REQUEST

Current Zoning: R-5 (single family residential)
Proposed Zoning: UR-2(CD) (urban residential, conditional)

Approximately 0.56 acres located on the south side of Spencer Street, east of E. 36th Street, west of Herrin Avenue.
(Council District 1 - Egleston)

The petition proposes to redevelop the site with up to three single family detached dwellings, at a density of 5.3 units per acre.

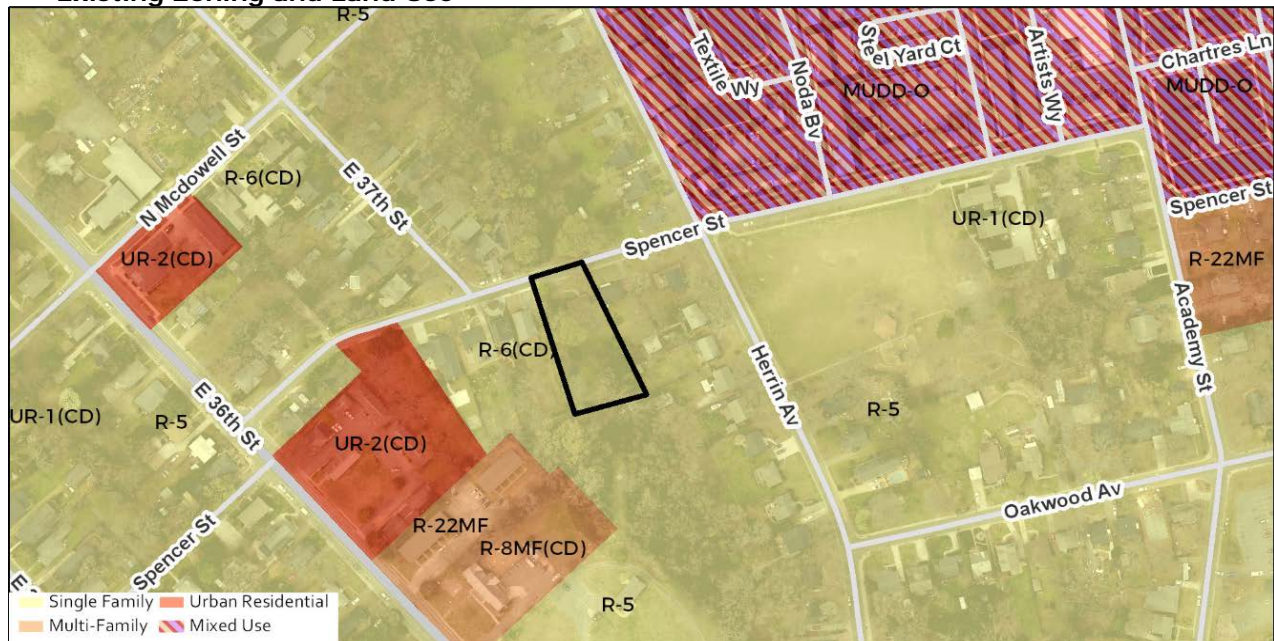
- The surrounding single family area has an established lot pattern with one home per lot and each home is oriented to and fronts the public street.
- The proposed development has three lots stacked on the site, with only the first lot allowing a new home to front and orient to Spencer Street.
- As currently designed, the proposed development is not consistent with the existing residential context described above, as the homes on two of the three lots will not face Spencer Street, but instead will face the rear of another home.
- Staff recommends redesigning the site to have lots that will result in homes that front on and orient to the street, similar to the lots immediately to the west of the site.

2. ~~Lay out lots to provide lots that contain one principal structure per lot, with the principal structures oriented to and fronting the public street.~~ **Not Addressed**
3. ~~Provide building setbacks along public streets that are compatible with those of the existing surrounding structures.~~ **Addressed**
